CIVA Rules, Judging, and Glider Aerobatics Committee Meetings

Rule Proposals for 2022 (Power and Glider Aerobatics)

Version 1.0 / 31 July 2021

Safety Figures

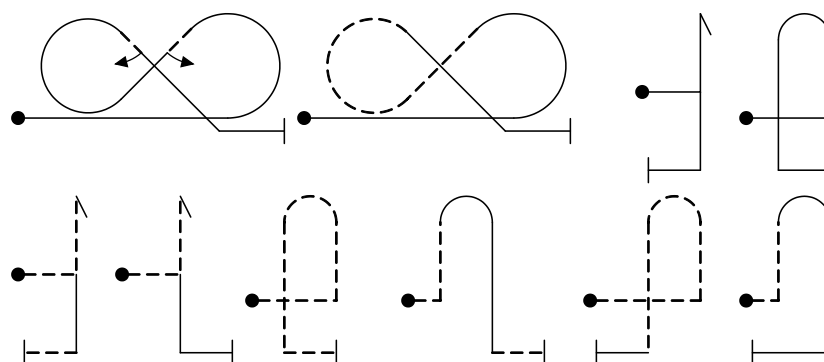
3.9.1.1. Before the wing-rocking at the start of each competition flight it is recommended that all pilots perform as a minimum the safety figures manoeuvres as follows.

3.9.1.2. In addition, the pilot may perform up to 4 of the following turns as warm up manoeuvres, separately or in one continuous turn:

To allow competitors additional safety figures before each programme to maximise physical preparedness (g-tolerance) for the flight ahead and specifically to combat g-loc.

It is proposed that the safety, **warm up** and practice figures be increased to include up to 4 half rolls, up to 4 90° level turns (inside or outside) and 3 of the permitted practice figures from the expanded list before **each** of the Programmes.

3.9. Safety and Practice Manoeuvres

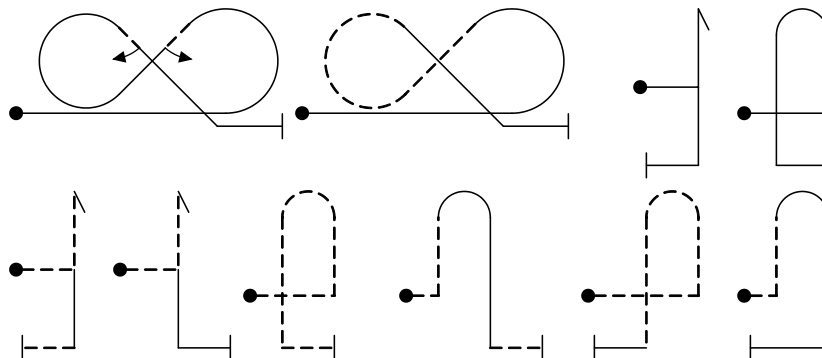
3.9.1.1. Before the wing-rocking at the start of each competition flight it is recommended that all pilots perform safety manoeuvres as follows. These figures are optional but, if flown, may be flown only once, in any order unless a figure starting inverted is used (see below), and continuously on the same axis. They must be flown inside the performance zone:

and up to three (Programme 1), or one (Programmes 2 to 5), of the following:
